CONTRACT CHANGE ORDER NO. 118
SHEET 3 OF 13

SAN FRANCISCO OAKLAND BAY BRIDGE
EAST SPAN SEISMIC SAFETY PROJECT
SELF-ANCHORED SUSPENSION BRIDGE (SUPERSTRUCTURE & TOWER)

TOWER HEAD DETAILS NO. 3

2:1

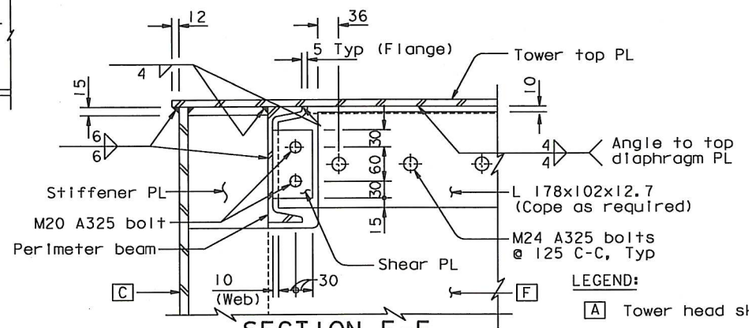
13. At the Contractor's option, the F plate may be spliced in the field with CJP welding or bolted splice, subject to review and approval of the Engineer. For bolted splice detail, see "Tower Head Details No.8" sheet.
14. For alternative diaphragm and framing confined by C, D and F, see "Tower Head Details No.10" sheet.

6. For tower access opening details, see "Tower Access Details" sheets.
7. Section E-E is shown rotated 90° counterclockwise.
8. At the Contractor's option, L127x76x12.7 may be used in lieu of L127x76x11.1, subject to review and approval of the Engineer.

9. At the Contractor's option, L152x102x12.7 may be be used in lieu of L152x102x11.1, subject to review and approval of the Engineer.
10. At the Contractor's option, 12 mm bent plate with two M16 A325 HS bolts on each side may be used to connect the perimeter beam at the corners, subject to review and approval of the Engineer.

11. Stiffeners may be terminated below the channel beams, subject to review and approval of the Engineer.
12. Railing posts shall be vertical.

TOWER ACCESS DETAILS NO. 4

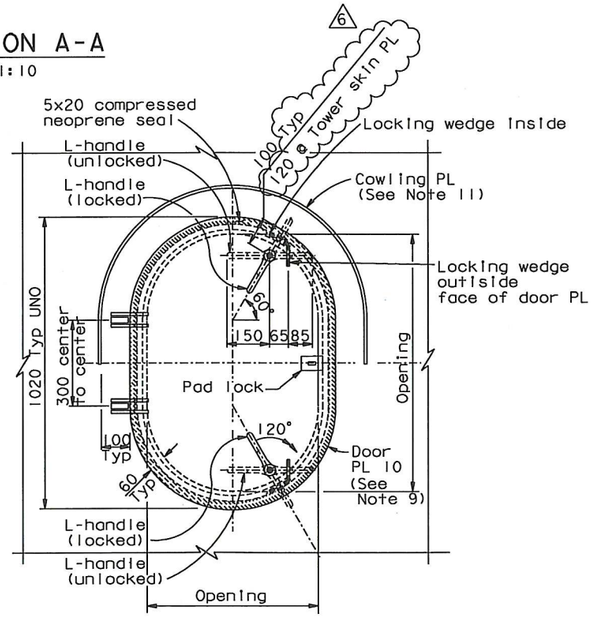
2. Doors shall be secured by cam locks with locking L-handles and interior release.
3. Door hinges shall be stainless lift-off type with 16 mm pin size 150 kg rated capacity per hinge.

7. Contractor shall provide internally mounted pivot hinges. No part of hinge shall protrude beyond the outside surface of door or facade when door is closed. Hinges shall permit door to swing outwards at least 120°. Each hinge shall be rated to resist 900 N in any direction.

8. Contractor shall provide through-hole mounted cam lock with key. Lock shall be flush with outside face of door.
9. Edges of door shall be sealed with a 6x20 Neoprene seal. The neoprene shall conform with Section 51-1.145, "Strip Waterstops," of the Standard Specifications, except the neoprene shall have a hardness of 40 +/-5.

10. Dehumidification access openings shall have R=50 mm typical. Dehumidification access openings at tower head only shall be 680 mm x 900 mm.
11. At interior access opening doors, cowling plates may be omitted, subject to review and approval of the Engineer.

14. For Section E-E and F-F, see "Tower Access Details No. 4B" sheet.
15. Doubler PL 50 on Tower Head Face F may be clipped to clear Tower Head Diaphragm PL. Minimum edge distance of 50 mm for M24 bolt shall be maintained.
